BREMEN ELEMENTARY SCHOOL

Re: Bremen ES / Fairfield County

This letter is written in follow up to a construction storm water inspection that I conducted at the Bremen Elementary School located at 210 Strayer Avenue in Bremen, Ohio on September 28, 2009. The purpose of the inspection was to evaluate compliance with the General Storm Water Permit Associated with Construction Activities. During the inspection, the following items were noted:

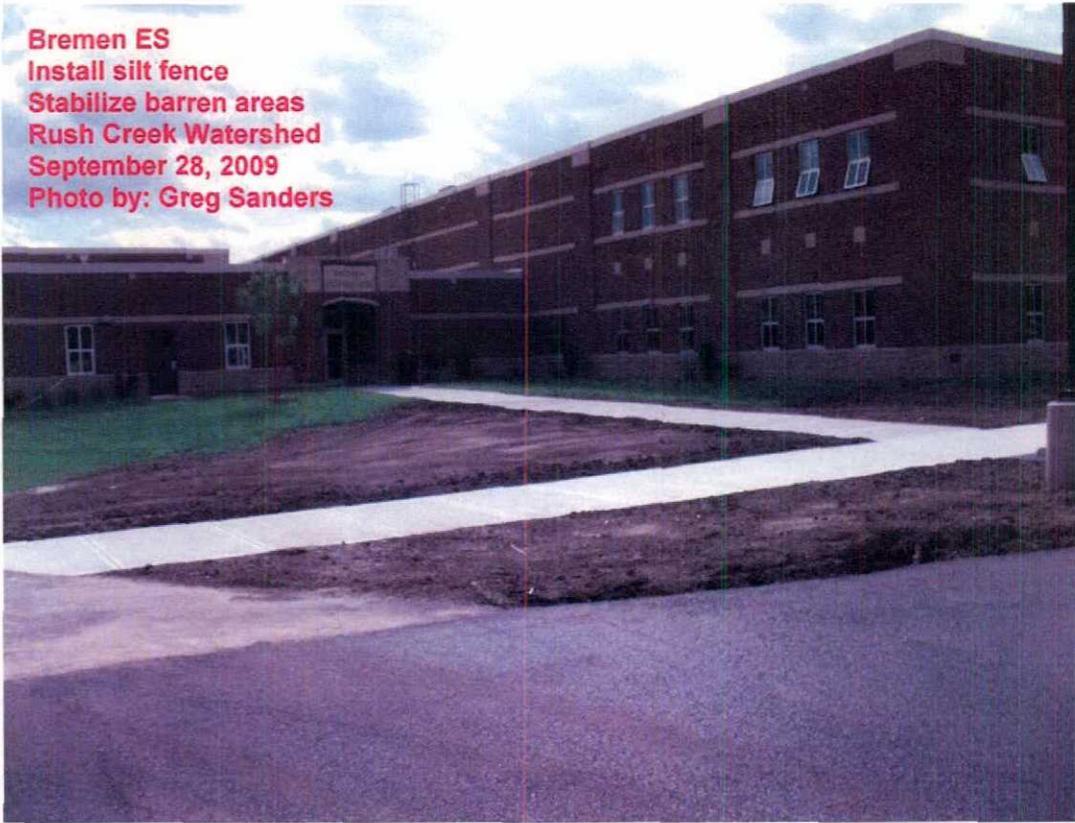
- Be aware the General Permit states that all barren areas which remain idle in excess of 21 days must be protected from erosion within seven days of the last earth disturbing activities. In addition, erosion protection must be implemented for all areas of final grade within seven (7) days. See attached pictures.

- The perimeter sediment controls implemented on this site will require reinstallation to ensure a proper functioning condition. See attached pictures. This general permit states that all sediment controls will be inspected and maintained every seven days or within 24 hours of a precipitation event equal to or greater than 0.5 inches. A log of inspection must be maintained on site for the agency to review.

Bremen ES
Install silt fence
Stabilize barren areas
Rush Creek Watershed
September 28, 2009
Photo by: Greg Sanders
